UPRIGHT VERTICAL ASSEMBLY 2 REQ'D & L2U2 TRUSS A + B

Vermont Agency of Transportation
RECEIVED

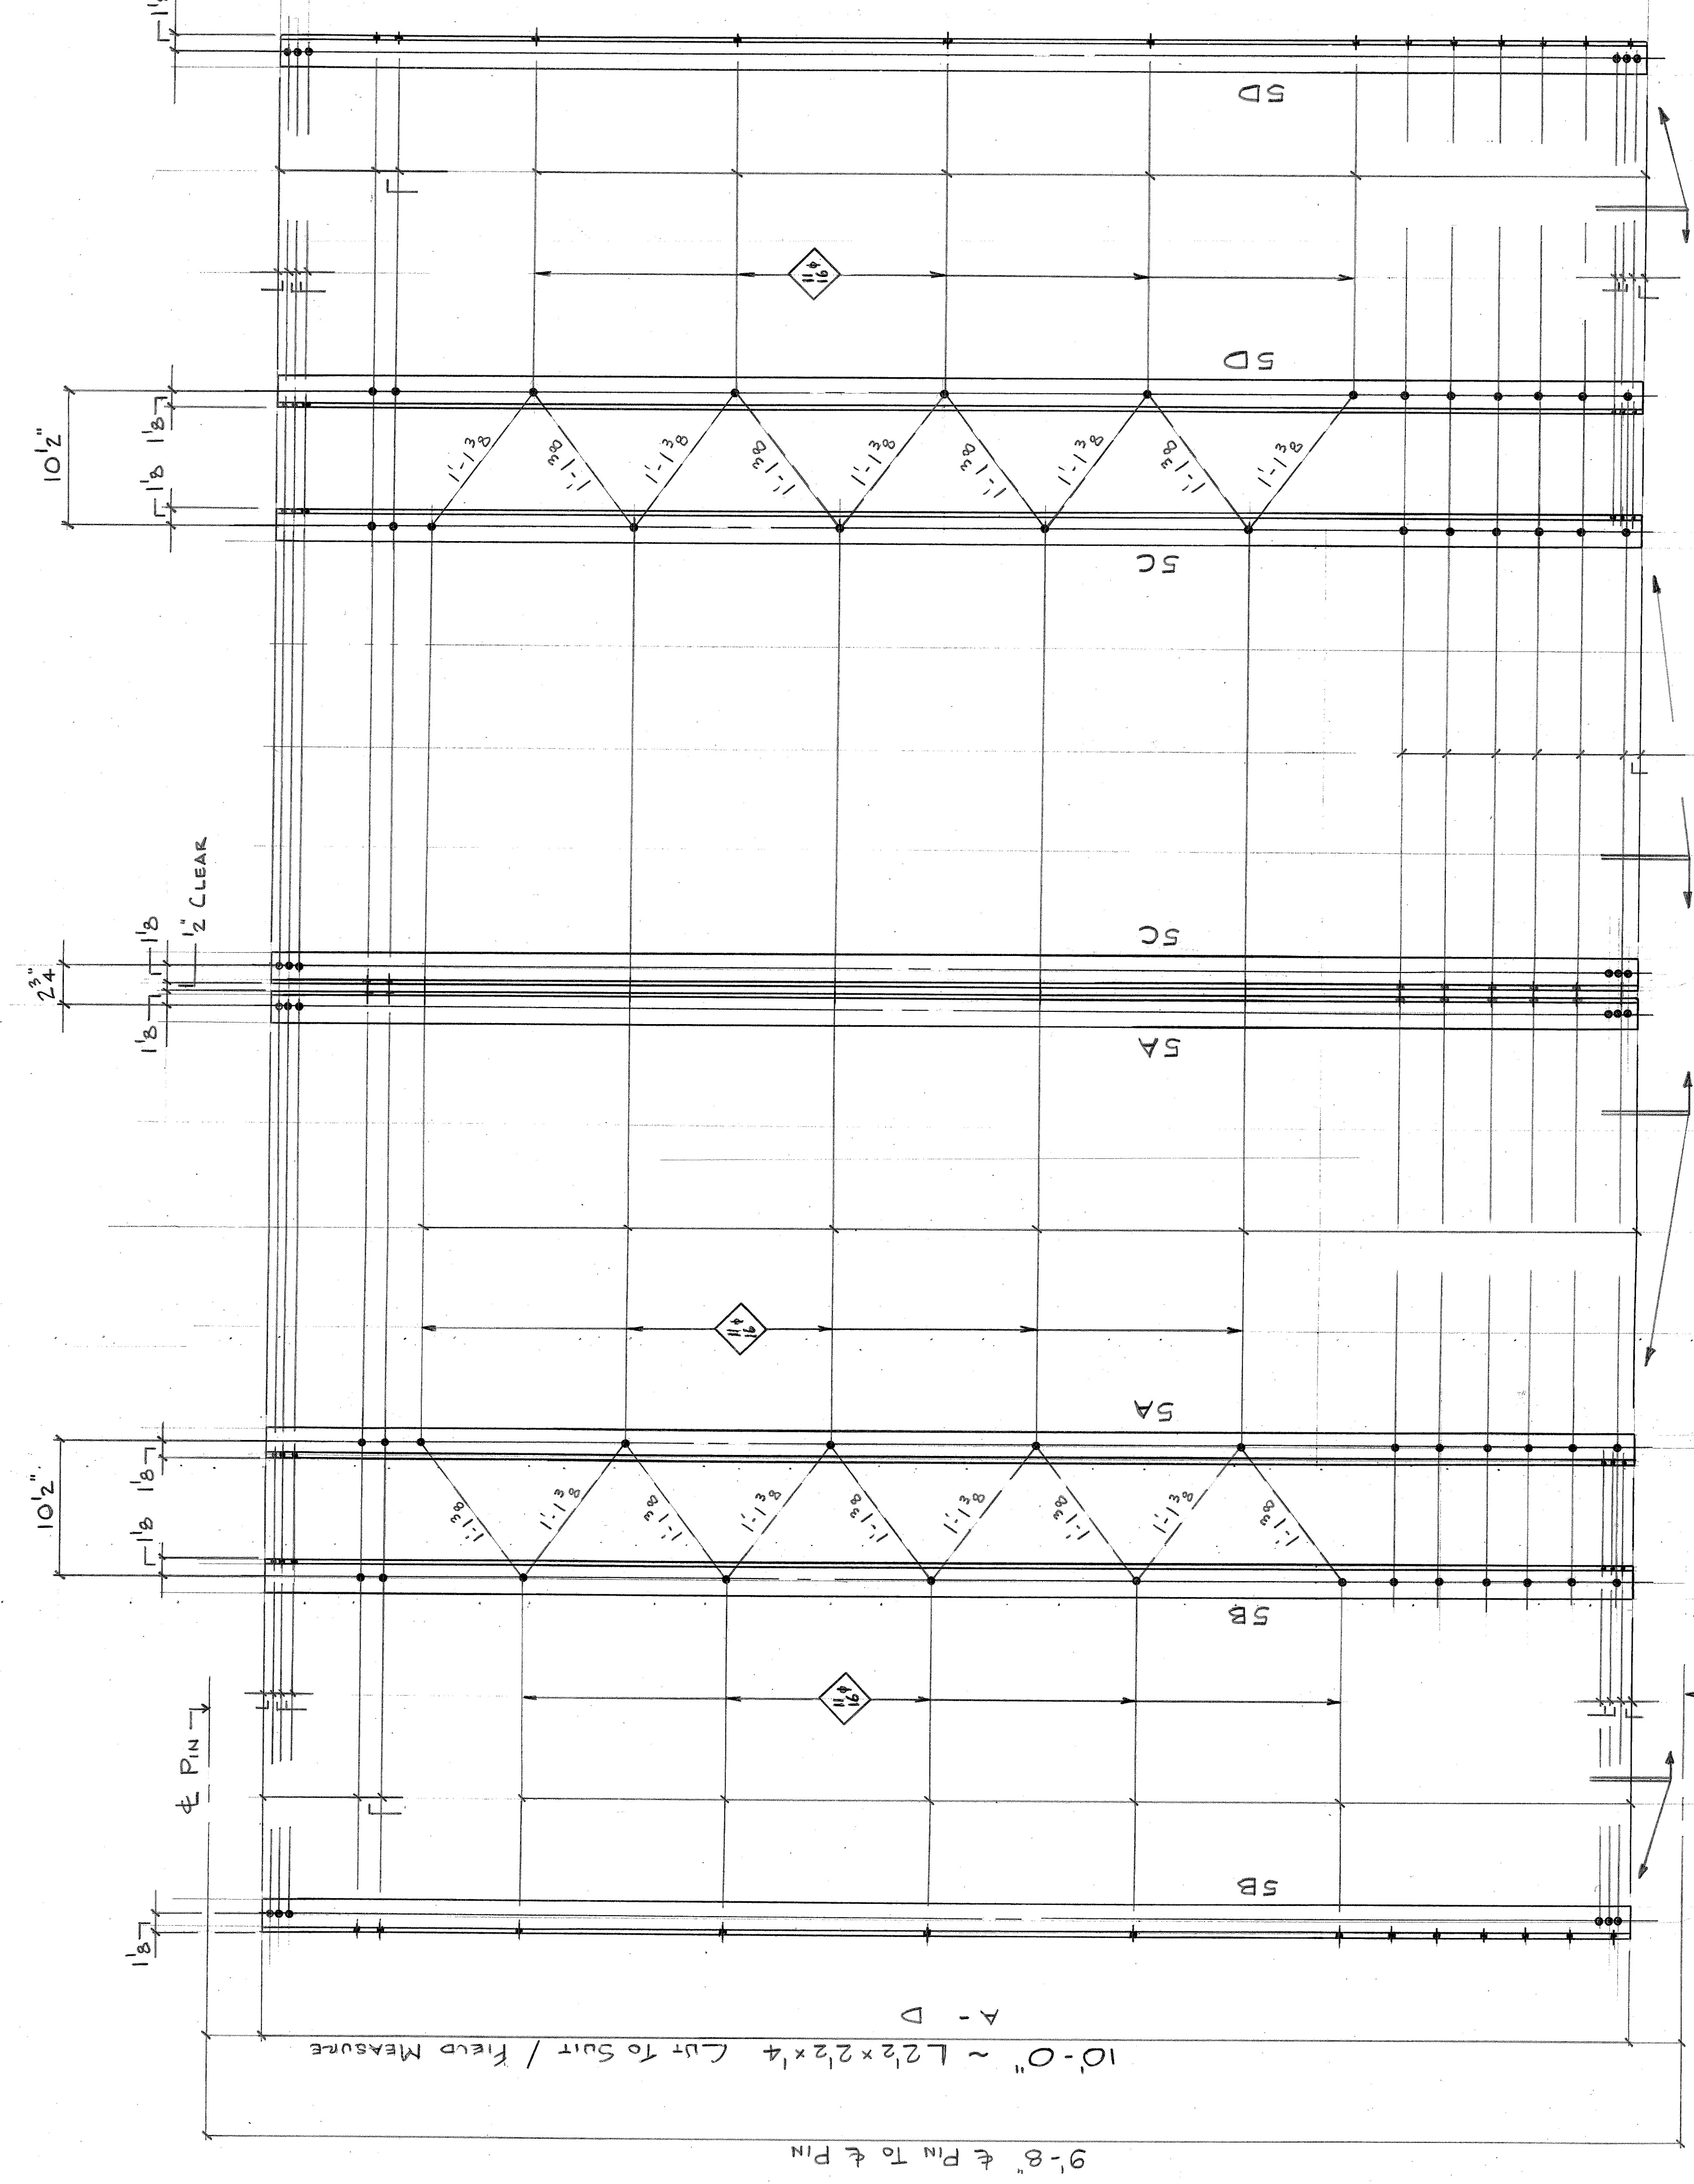
The replacement of members EPI, U1-U2, U2-U1, and EPI necessitates different details than shown on this sheet. See Sheets 10-13 (1/4-4/4) for modifications.

RESUBMIT APPROVED As Noted
BY KMH DATE 9/10/2012
